Model: Cover Interposer Tray CI5030 (D738)		Date: 7-May-15	No.: RD738001
Subject: Part change - Compression springs		Prepared by: T. Suzuki	
From: MFP Tech Service Dept., 2nd MFP Tech Service Sect.			
Classification:	<input type="checkbox"/> Troubleshooting <input type="checkbox"/> Mechanical <input type="checkbox"/> Paper path <input type="checkbox"/> Product Safety	<input checked="" type="checkbox"/> Part information <input type="checkbox"/> Electrical <input type="checkbox"/> Transmit/receive <input type="checkbox"/> Other ()	<input type="checkbox"/> Action required <input type="checkbox"/> Service manual revision <input type="checkbox"/> Retrofit information <input type="checkbox"/> Tier2

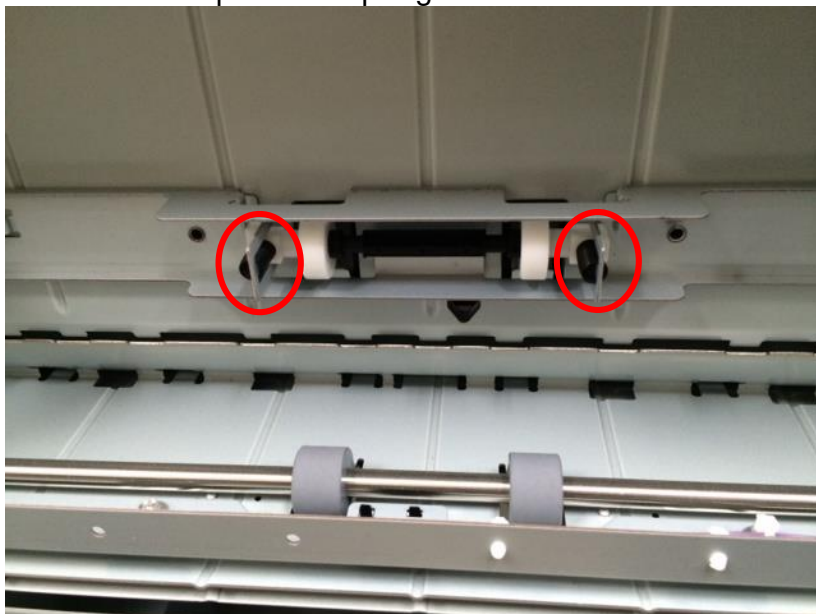
CHANGE: Compression springs were changed to those without the antirust compound.

REASON: The antirust compound dissolves the adjacent plastic components.

A total of 8 compression springs are installed at the following locations; 2 springs for each of the 4 rollers circled.

Old p/n	New p/n	Description	Q'ty	Int	Note
A6972187	D7382187	COMPRESSION SPRING: DRIVEN:PROOF TRAY	8	X/O	Change

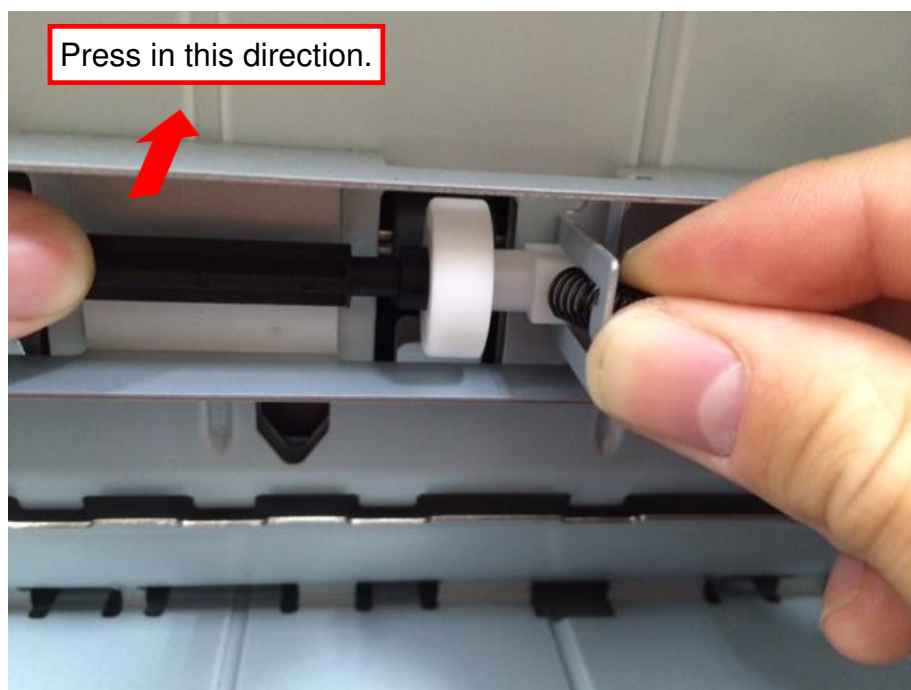
1. Locate the compression springs from the side of the unit.

2. To remove the compression spring, press the black shaft toward the unit and release the pressure from the compression spring.

3. Do the same for the other side.

4. Replace with the new compression springs.
5. Repeat the above steps for the remaining 3 rollers to complete the procedure.
